MONITORING YEAR 2 ANNUAL REPORT

ALEXANDER FARM MITIGATION SITE

RE: Draft Year 2 Monitoring Report
Alexander Farm Mitigation Site, Alexander County
Yadkin River CU 03040101
DMS Project ID No. 100022 / DEQ Contract #007186

Wildlands Engineering, Inc. (Wildlands) has reviewed the Division of Mitigation Services (DMS) comments from the Draft Year 2 Monitoring Report for the Alexander Farm Mitigation Site. The report has been updated to reflect those comments. The Final MY2 Report is included. DMS' comments are listed below in **bold**. Wildlands' responses to DMS' comments are noted in *italics*. Comments received via email on January 4, 2022 are also included.

Alexander Farm Supplemental Planting Areas (MY2)

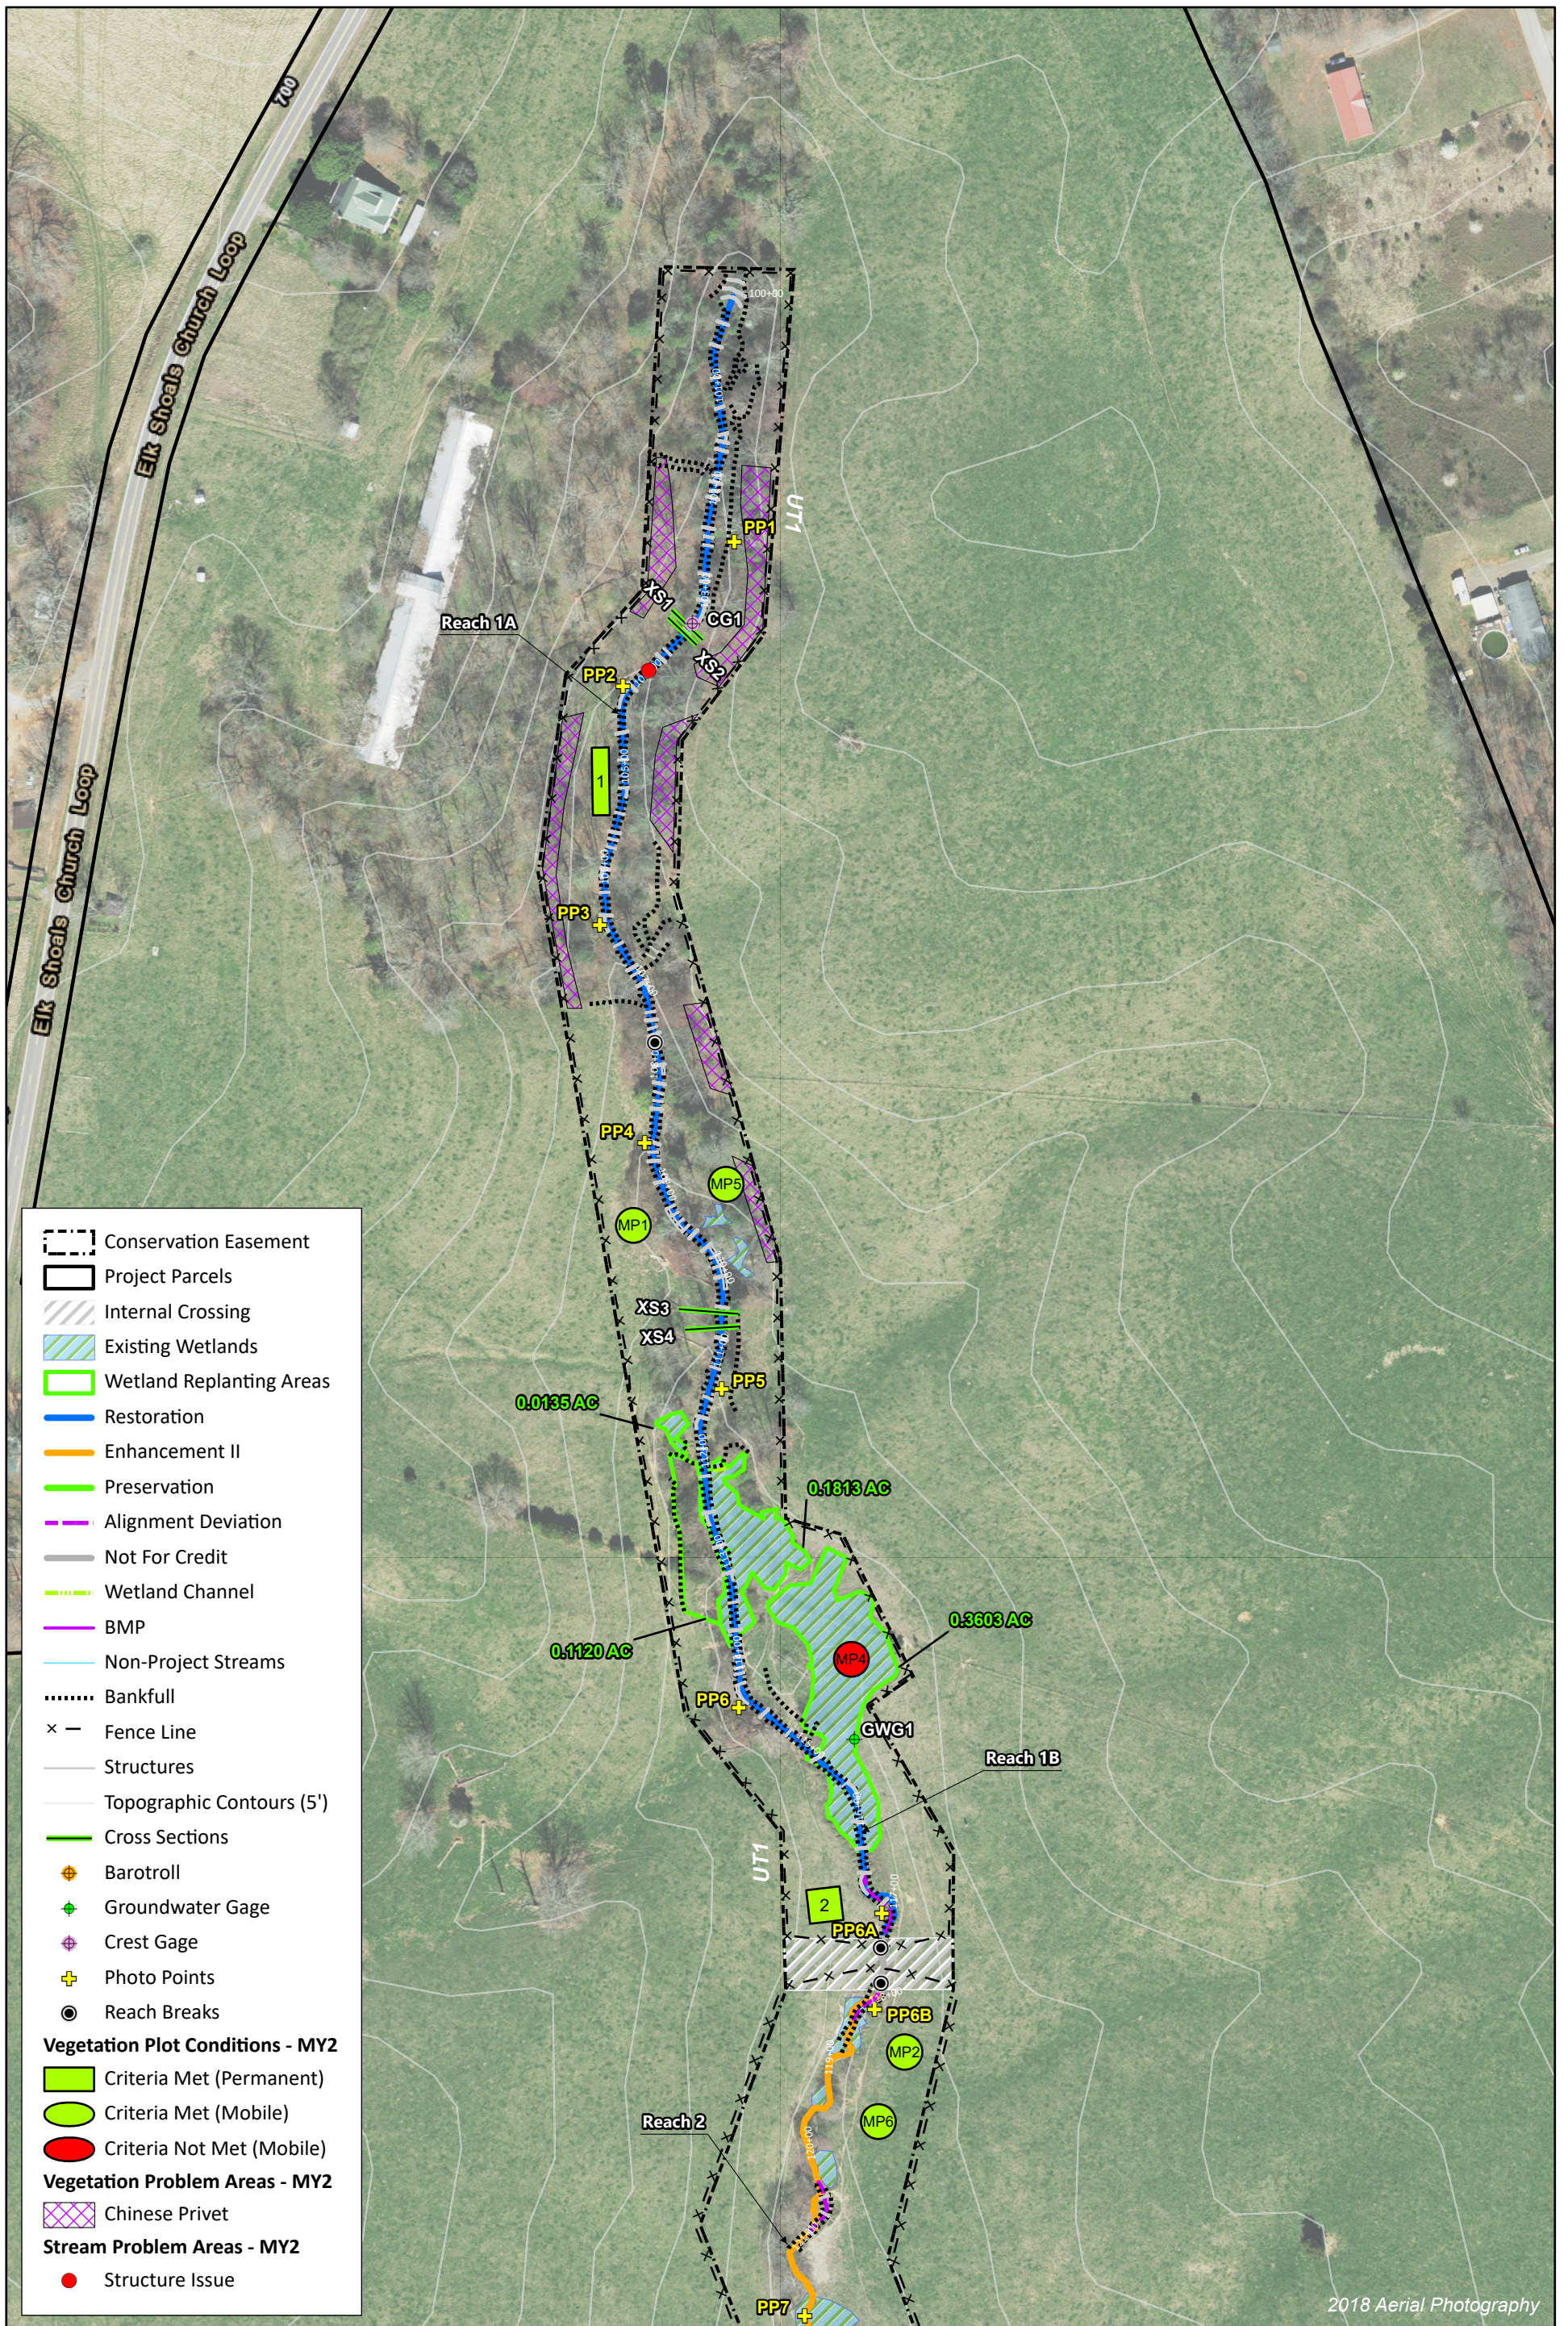
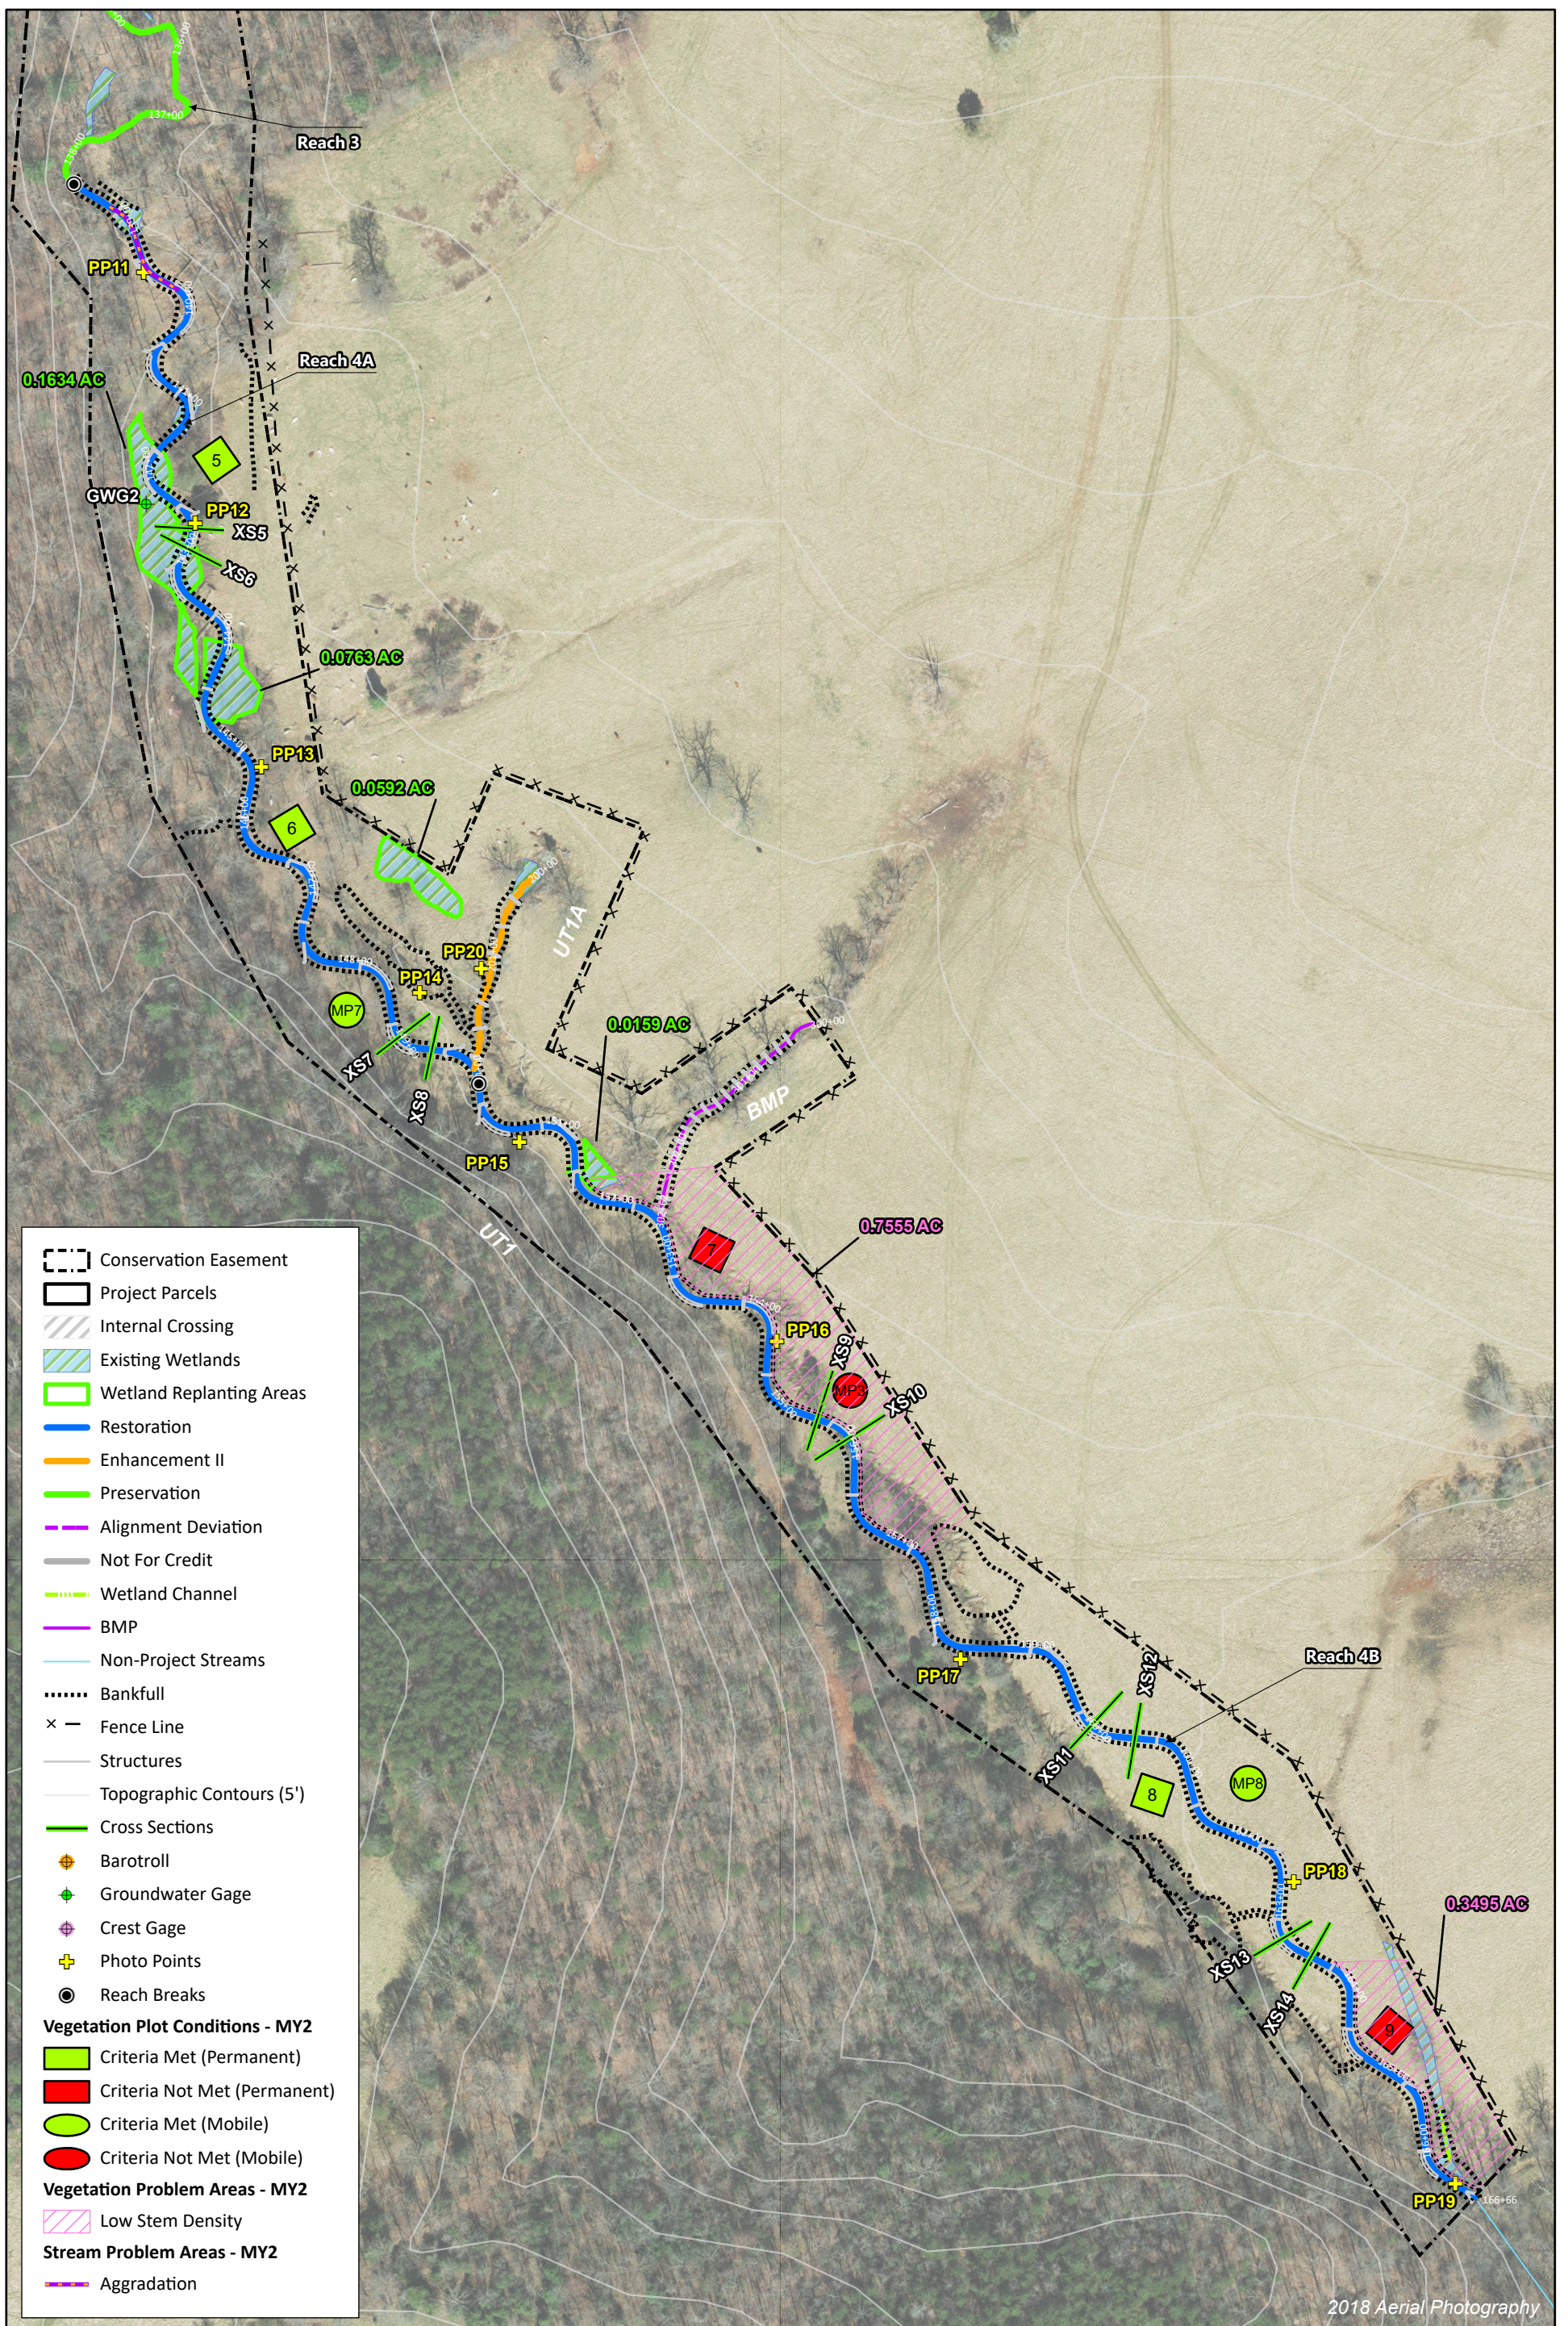
DMS' comment: Please include the winter 2022 planting maps in Appendix 7, and the email transmittal, to go along with the table; When discussing the wet areas intended to be supplementally planted in Winter 2022 (sec. 1.2.3), please reference Appendix 7.

Wildlands' response: Wildlands has included the proposed planting list, the email correspondence, and the maps showing the supplemental planting areas in Appendix 7. The supplemental planting areas are depicted in a bright green outline and/or a pink diagonal hatch.
